ADDENDUM NO. 02

PROJECT: IFB 197016 – CORONA DE TUCSON DISINFECTION AND SERVICE WATER
PROJECT NO. 3CDT22

Immediately Following This Page is As-Built Drawing C-6 (1 page)

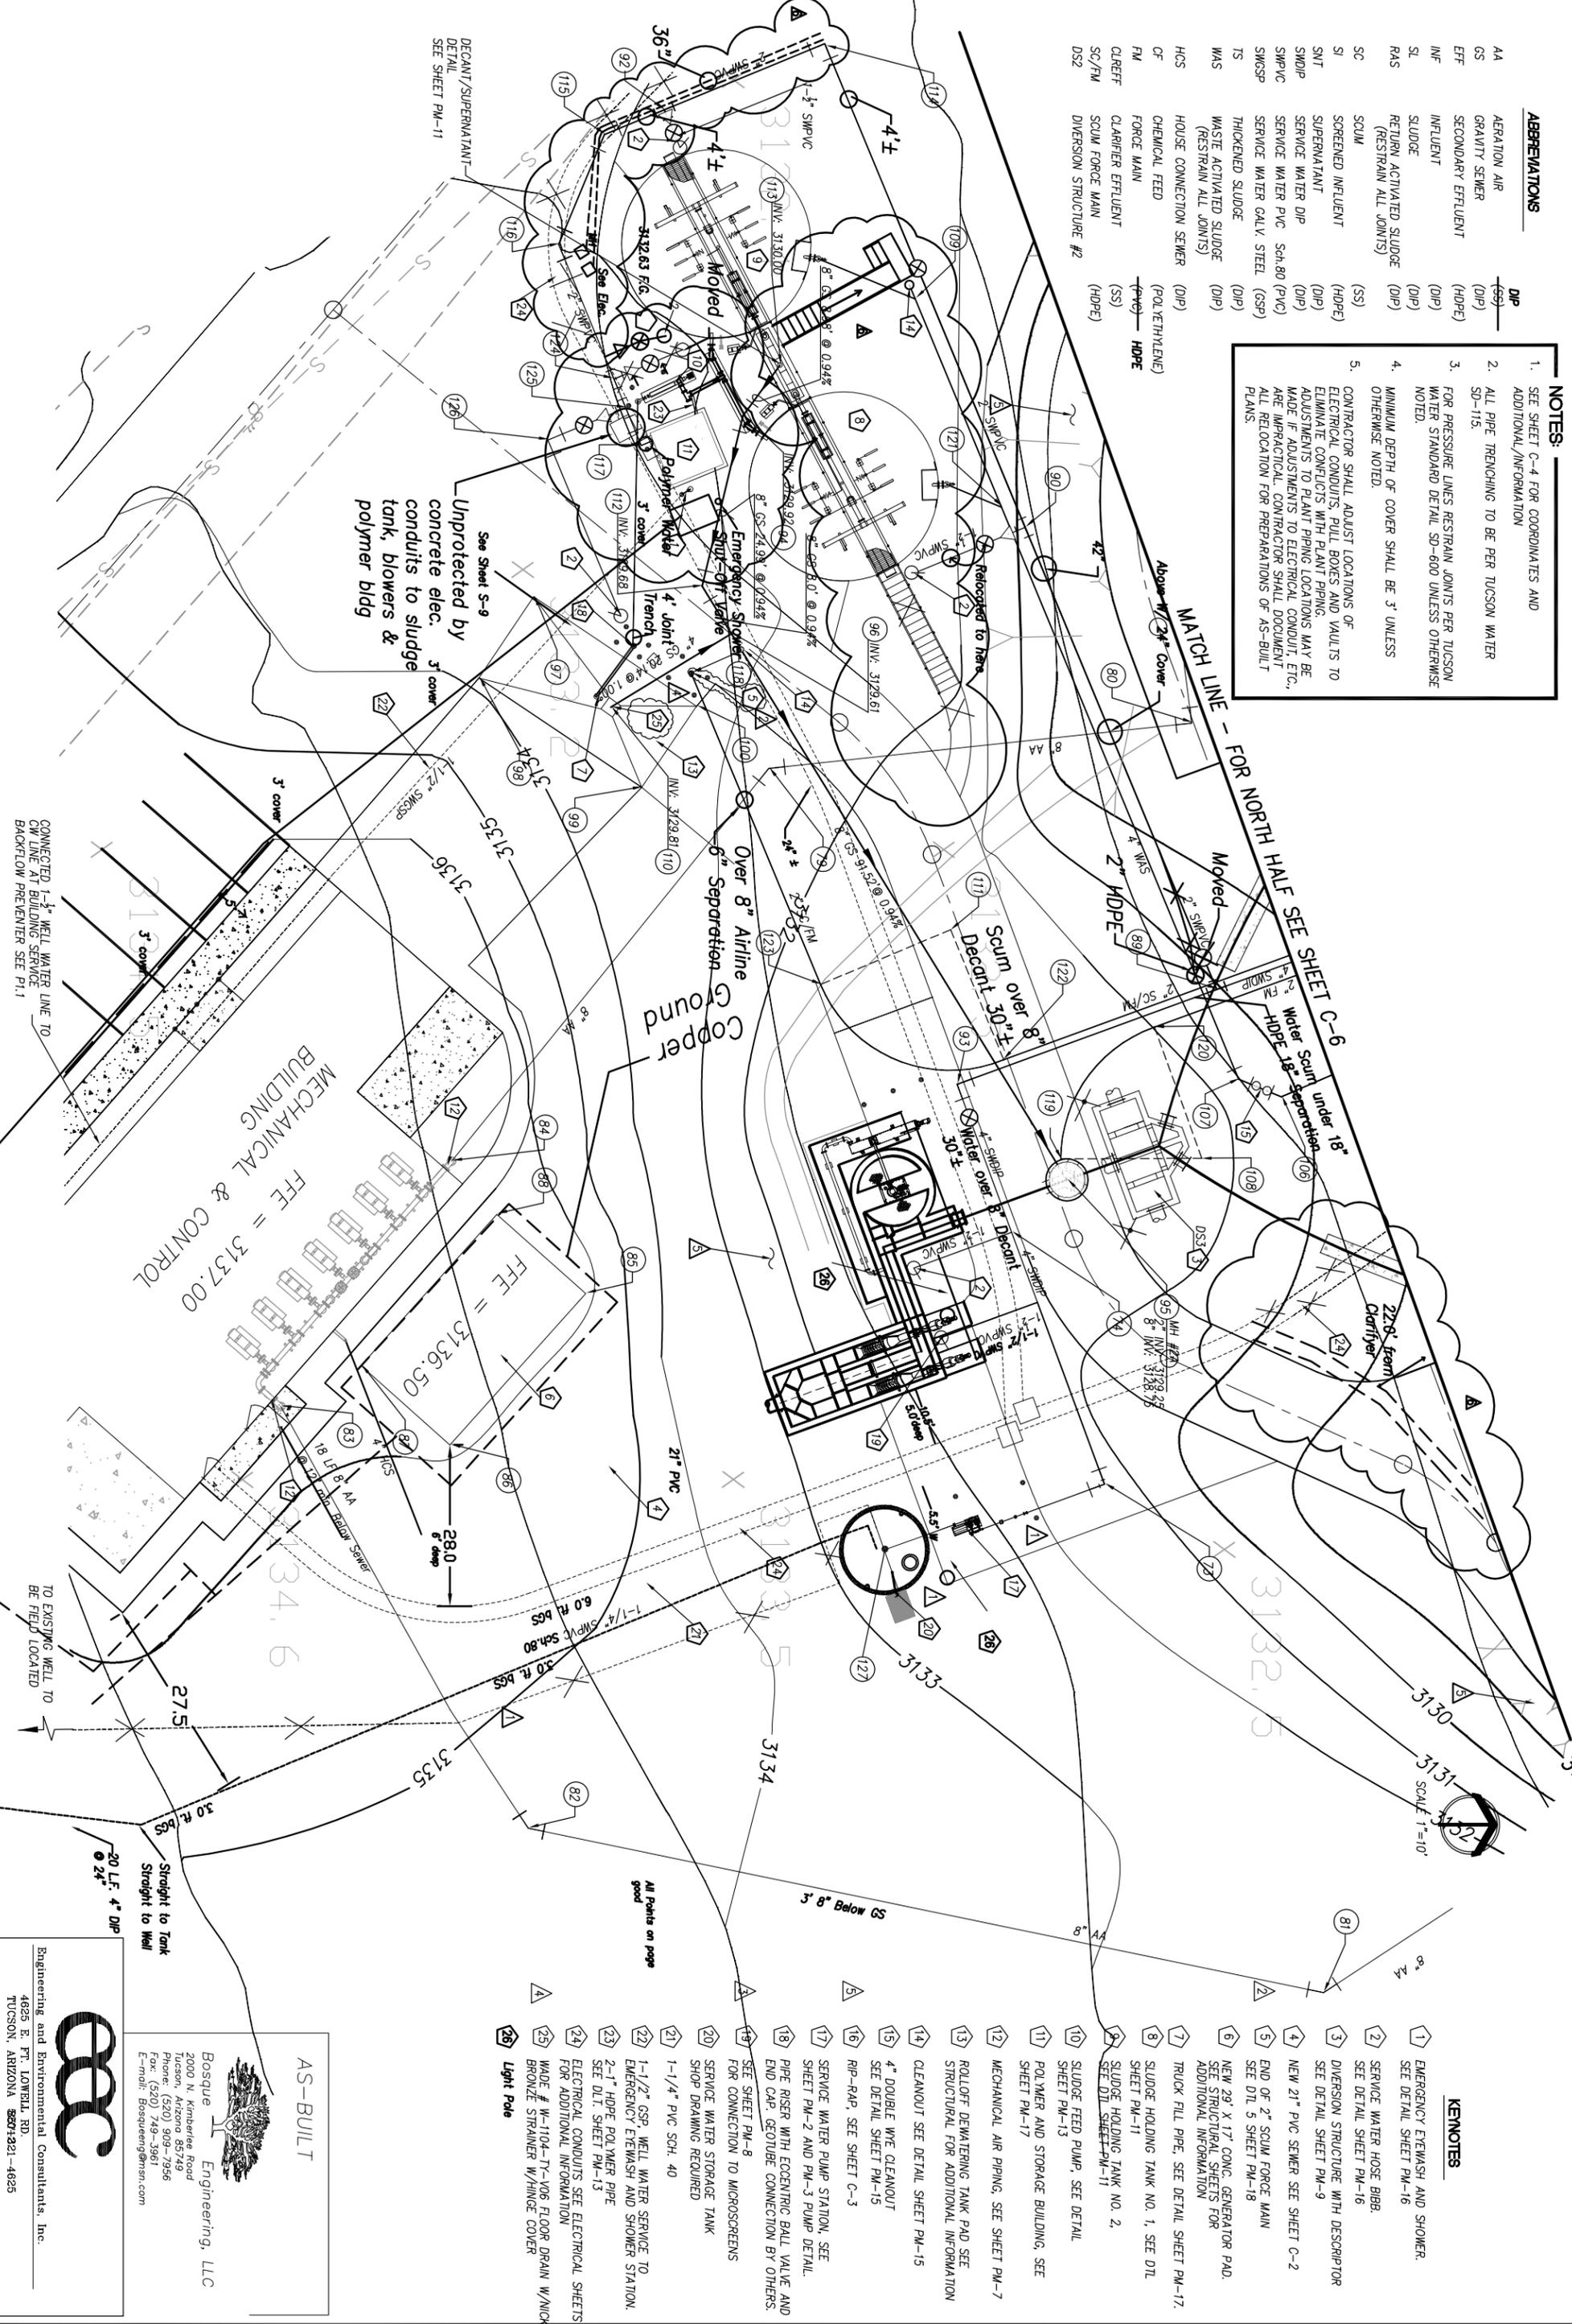
- Q: General Notes 1 and 2 on Sheet C-1 directs the contractor to 2007 As-Built Drawings C-6 and C-7. With the County provide copies of these As-Builts?
 - A: Yes, the As-Builts are made available as attachments to this addendum.
